# Citizens Committee to Complete the Refuge

Re: Final Environmental Assessment Cargill, Incorporated Solar Sea Salt System Maintenance and Operations Activities Project (BCDC Permit Application 2021.003.00)

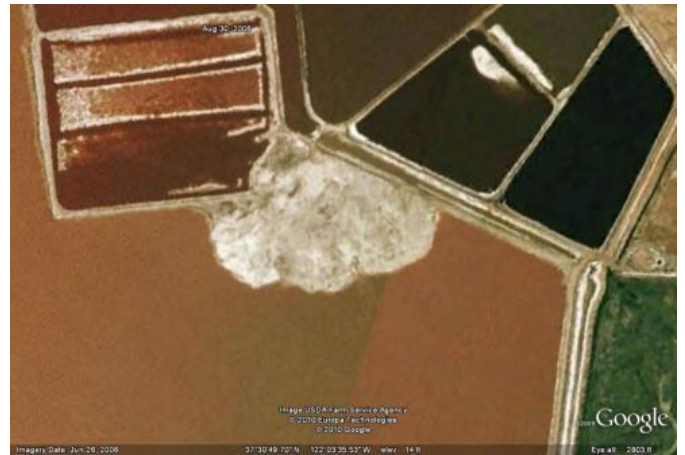
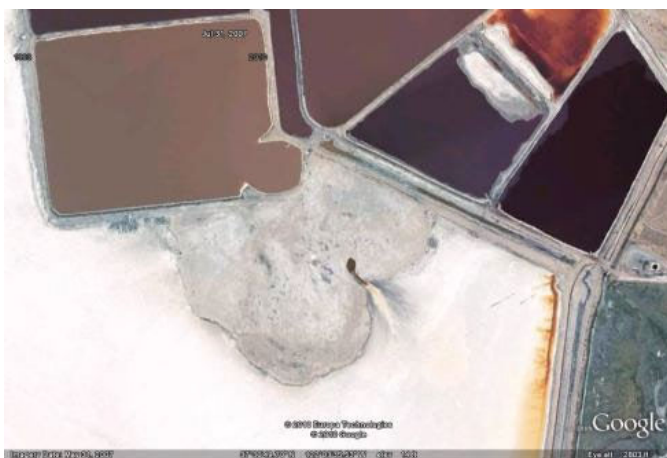
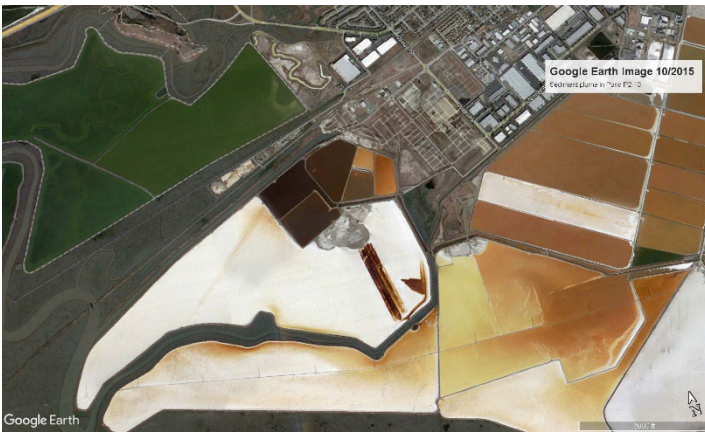
In response to the Recirculated Draft Environmental Assessment, CCCR submitted the photos similar to those provided below, questioning whether the fan of sediment (not salts) depicted within Pond P2-13 is considered a “minor fill.”

The area of sediment deposition in Pond P2-13 did not exist prior to July 2004. By August 2009, a GIS analysis approximated the size of the fan of sediment to cover approximately 18 acres of the pond bottom of P2-13.

Does the same response apply for the sediment deposited in pond P2-10?

Estimates of the areal extent of the fill pad on top of the pond bottom of Pond P2-13 was approximately 18 acres as of 2009, which seems significant. It clearly results in a change in the pond bottom elevation. These do not appear to be deposits of salts, but instead appear to be deposits of sediment that remain in place over significant periods of time.

Is an activity that results in the creation of an 18-acre sediment fan on top of the pond bottom not regulated at all? Will this activity cease or will these sediment fans continue to grow over time?

"Cargill has indicated that these photos do not represent fill. The material on the northwest side of Pond P2-13 consists of mixed sea salts within the pond that were moved around. Cargill manages the distribution of mixed sea salts in the ponds to manage and harvest brine and manage rain water."

Sediment deposits in Ponds P2- 13 and P2-10

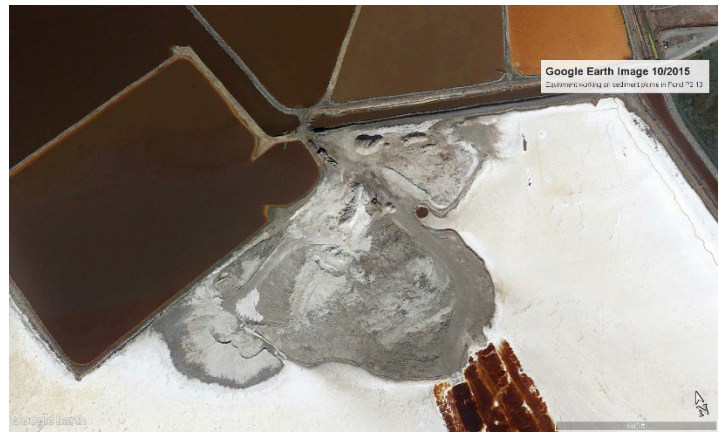
Visual analysis of a Google Earth image from October 2015 indicates this deposition of sediment has continued to grow.

Mounds of sediment can be seen on top of the sediment deposition and equipment working the sediment can be observed in the image.

A similar situation can be observed in Pond P2-10, with sediment depositions on top of the pond bottom visible after 2007.
